CITY OF ALBUQUERQUE

Re: Shopping Center
1220 Eubank NE
Traffic Circulation Layout
Engineer's/Architect's Stamp dated 4-4-16 (J21-D045)

Based upon the information provided in your submittal received 4-5-16, the above referenced plan cannot be approved for Building Permit until the following comments are addressed:

TRAFFIC CIRCULATION LAYOUT

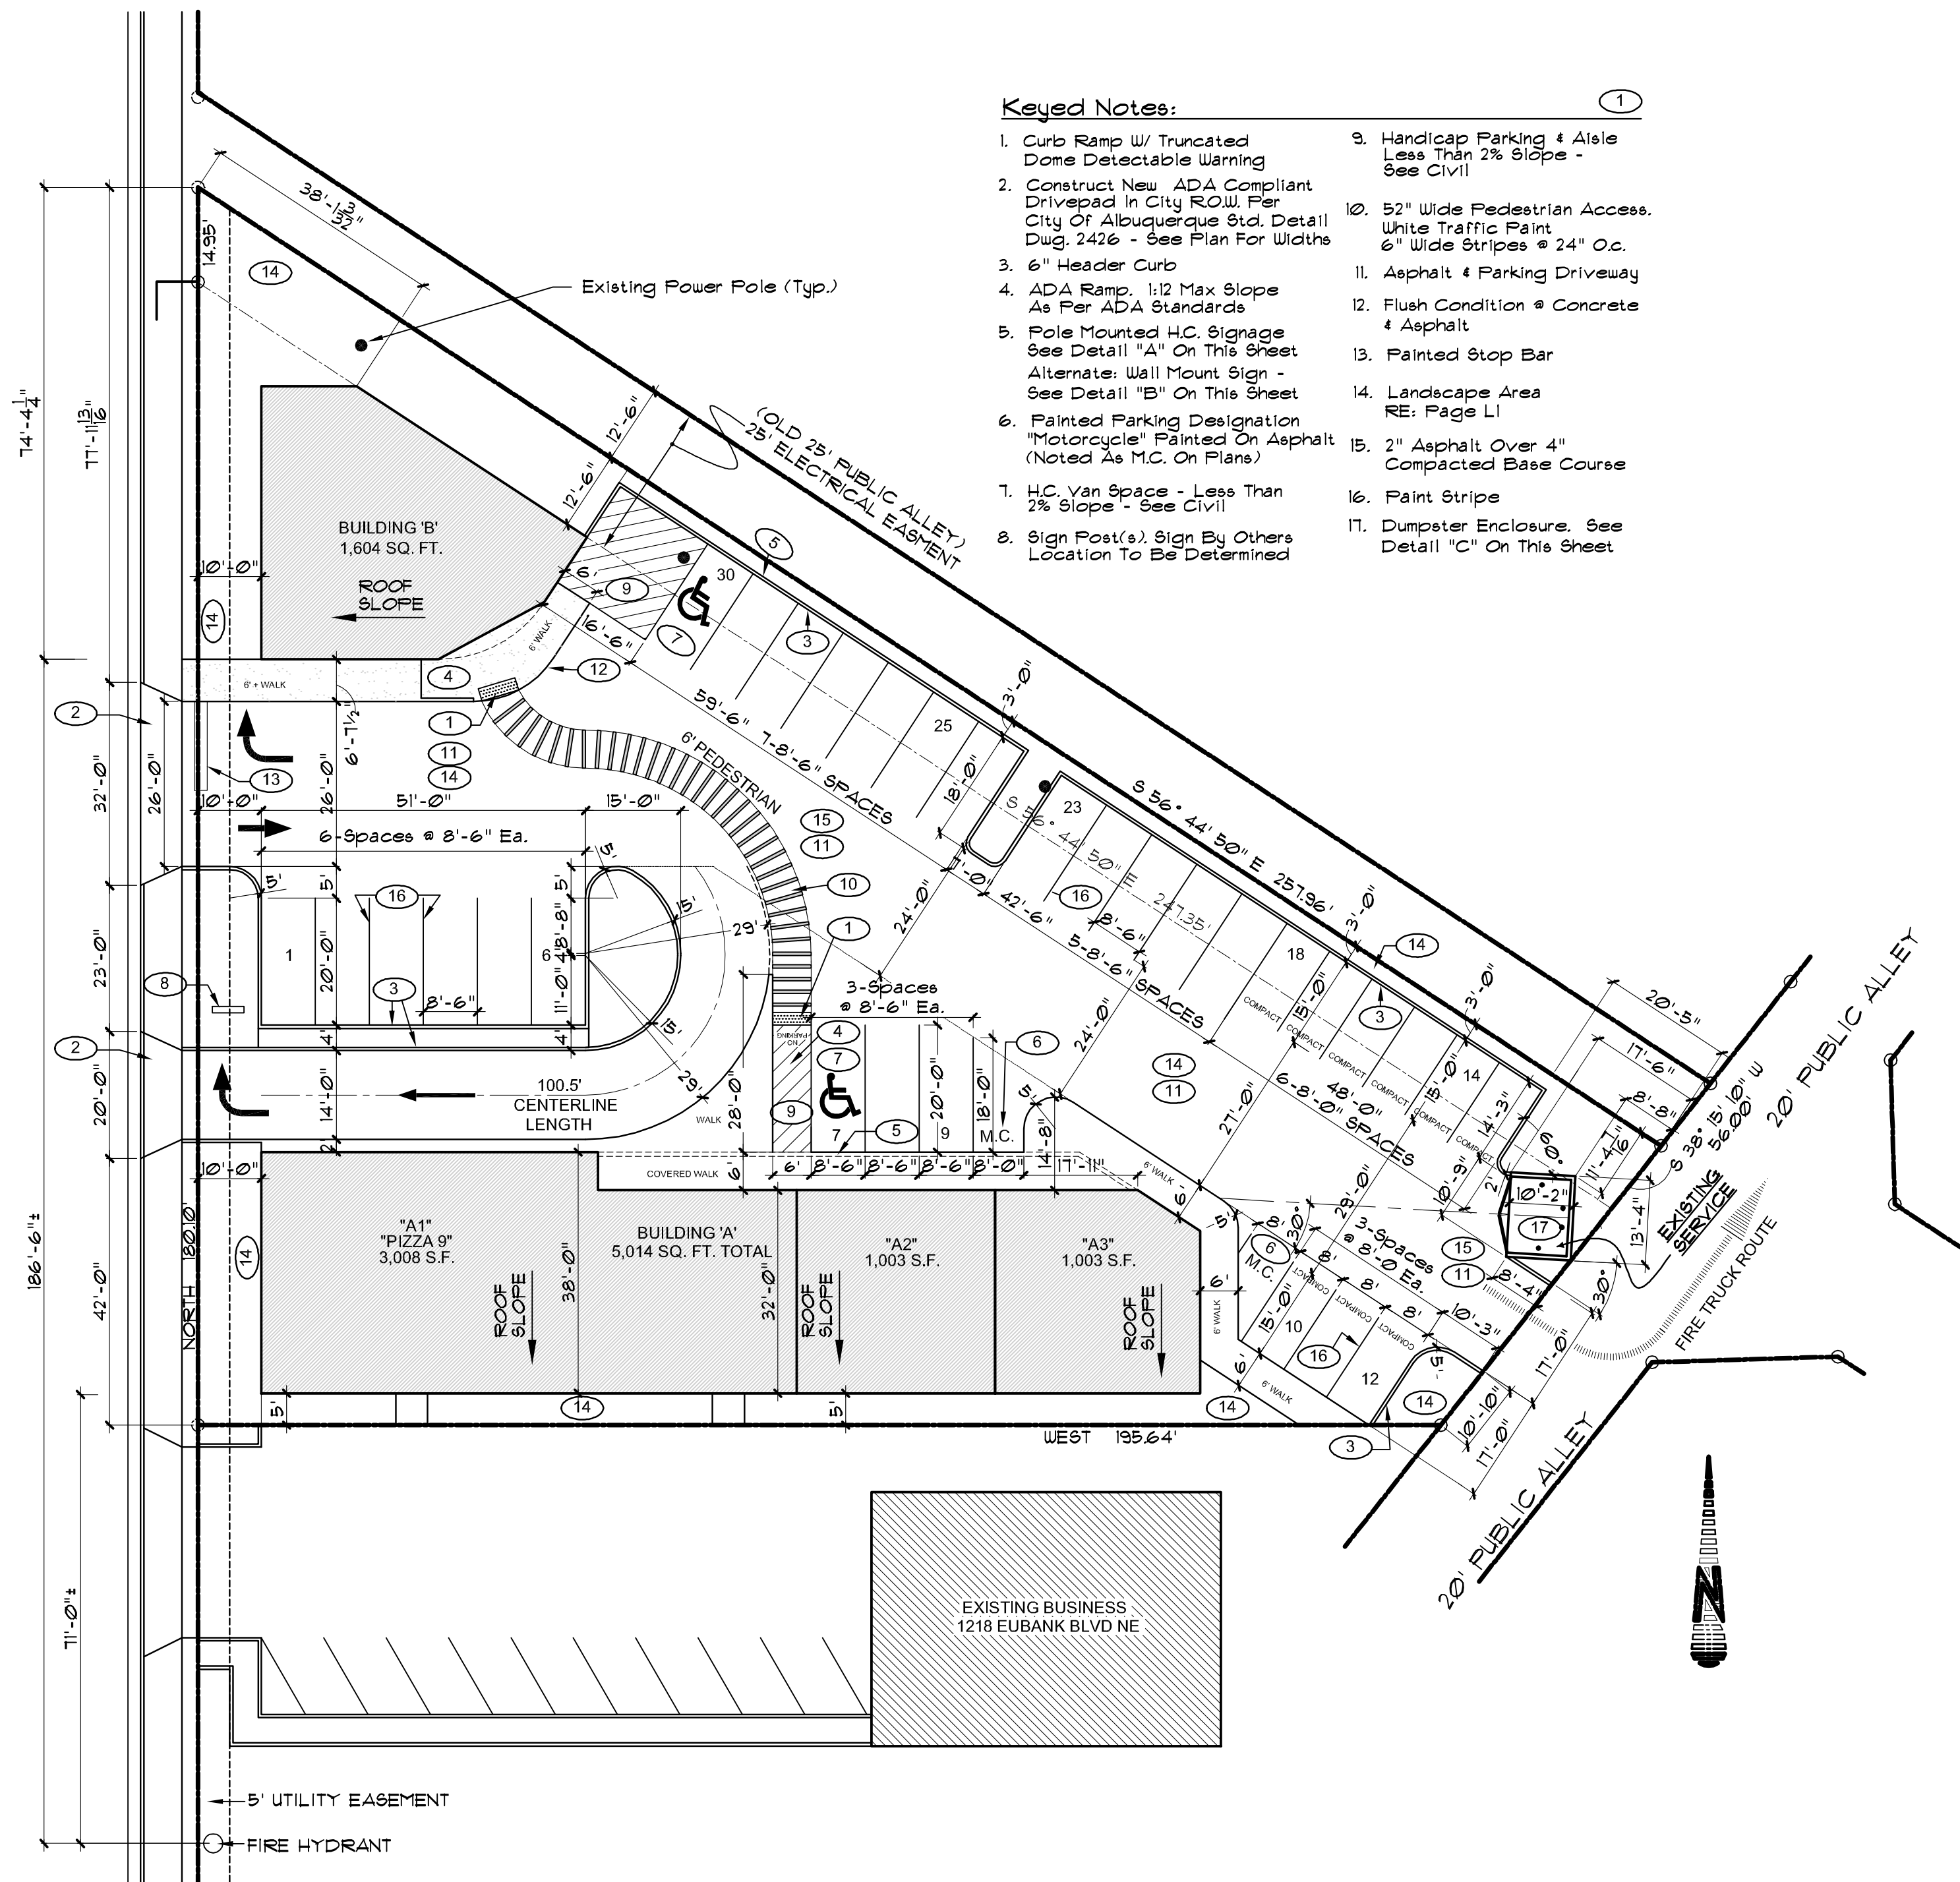
1. Please show a vicinity map showing the location of the development in relation to streets and well known landmarks.
2. List the number of parking spaces required by the zoning code as well as the proposed number of parking spaces.

3. Clarify the extents of the current phase.
4. Please detail the queuing length and show traffic flow directional arrows and signage for Drive-Thru.
5. Please identify all existing buildings, doors, structures, sidewalks, curbs, drive pads, wall and anything that influences the parking and circulation on the site.

6. Identify all existing access easements and rights of way width dimensions.
7. Identify the right of way width, medians, curb cuts, and street widths on Eubank Blvd. and the private alley to the east of the proposed project.

8. Please list the width and length for all existing and proposed parking spaces.
9. The handicap accessible spaces must be a minimum of 8.5 ft. in width.

10. The handicap accessible spaces must include an 8 ft. wide van access aisle; all other aisles should be 5 ft. in width.
11. The ADA accessible parking sign must have the required language per 66-7-352.4C NMSA 1978 **"Violators Are Subject to a Fine and/or Towing."** Please call out detail and location of HC signs.

12. The ADA access aisles shall have the words **"NO PARKING"** in capital letters, each of which shall be at least one foot high and at least two inches wide,

placed at the rear of the parking space so as to be close to where an adjacent vehicle's rear tire would be placed. (66-1-4.1.B NMSA 1978)

13. Show all drive aisle widths and radii.
14. Per DPM, a 6 ft. wide ADA accessible pedestrian pathway is required from the public sidewalk to the building entrances. Please clearly show this pathway and provide details from Eubank Blvd.

15. Per DPM, a 6 ft. wide ADA accessible pedestrian pathway is required from the HC parking stall access aisles to the building entrances. Please clearly show this pathway and provide details. Please clearly show this detail for each building.

16. Truncated domes will be required at all public drive pad entrances/exits. Please show this detail.
17. Design delivery vehicle route needs to be shown.

18. Service vehicle and/or refuse vehicle maneuvering must be contained on-site; provide a copy of refuse approval.
19. One-way vehicular paths require pavement directional signage and a posted **"Do Not Enter"** sign at the point of egress. Please show detail and location of posted signs.

20. It is not apparent what type of pavement surface is being proposed. A hard driving surface will be required as part of this proposed project for parking area and drive aisles.

21. Please provide a sight distance exhibit (see the *Development Process Manual, Chapter 23, Section 3*). Please provide a Clear Sight Triangle detail for major streets for the entrances/exits off of Eubank Blvd. See attached definitions from Development Process Manual.

22. Please add the following note to the clear sight triangle: "Landscaping and signage will not interfere with clear sight requirements. Therefore, signs, walls, trees, and shrubbery between 3 and 8 feet tall (as measured from the gutter pan) will not be acceptable in this area."

23. Please include a copy of your shared access agreement with the adjacent property owner.
24. See Chapter 23, Section 6 of the City of Albuquerque *Development Process Manual*, for appropriate drive pad widths. The drive pad entrance/exit at the south east corner to the public alley must be a minimum of 25 ft. wide.

25. Unused curb cuts must be replaced with sidewalk and curb & gutter. A build note must be provided referring to the appropriate City Standard drawing.

26. All broken or cracked sidewalk must be replaced with sidewalk and curb & gutter. A build note must be provided referring to the appropriate City Standard drawing.
